Dewan Fashion Wears Ltd. (Relocated)

Mamun Nagor, Sarabo, Kashimpur, Gazipur.

09 July 2023

Observations

**Additional slab portion at front not considered
in the design report**

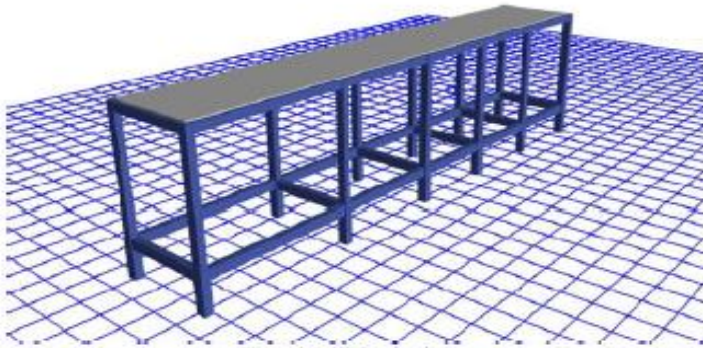
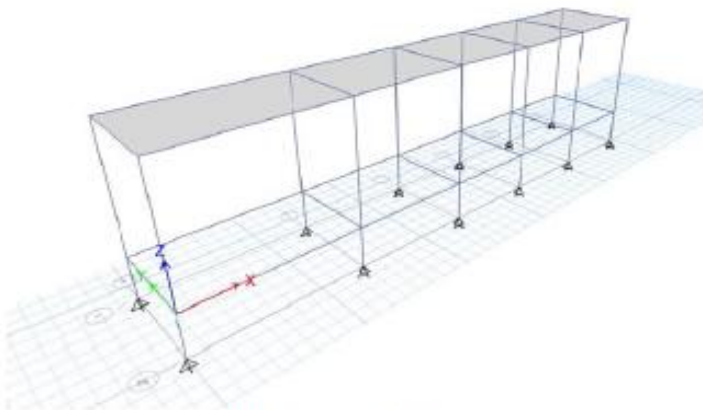
Additional slab at front was not considered in the design report. Building engineer is required to revise the design report considering figure of the structure.
